Application Number: 10/814,378

Appellant(s): PHILLIPS, DOUGLAS

EXAMINER'S ANSWER

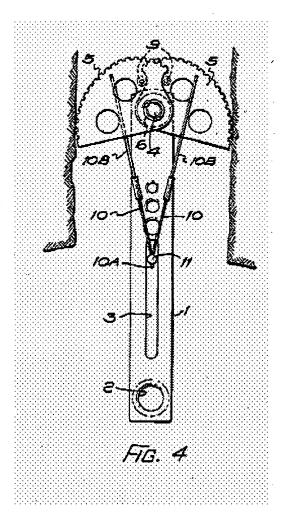
to the surface of the rocks is of a small degree, the devices is not situated within the crevice securely. This small degree of contact area causes the placement of the cams to be of proper quality and would cause the aid with any slight movement due to force to allow the device to fall out of the crevice because there would be no other gripping teeth to maintain the aid within the space since the device is expanded so close to the end of its contact area.

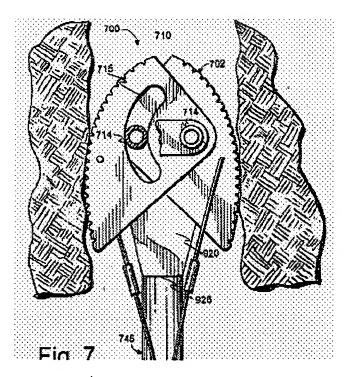
The climber would know that if the cams are in a more compressed state (as shown best in Watts Figure 7 included below) that the contact area of the cams relative to the rocks is greater which allows the aid to move in the vertical direction slightly due to force without the high possibly of the aid falling out the crevice due to the aid be capable of expanding further and allowing the remaining teeth or gripping area to catch within the crevice or crack. Based on this the gripping teeth are clearly visible placement indicia for experienced climbers that indicated quality of placement.
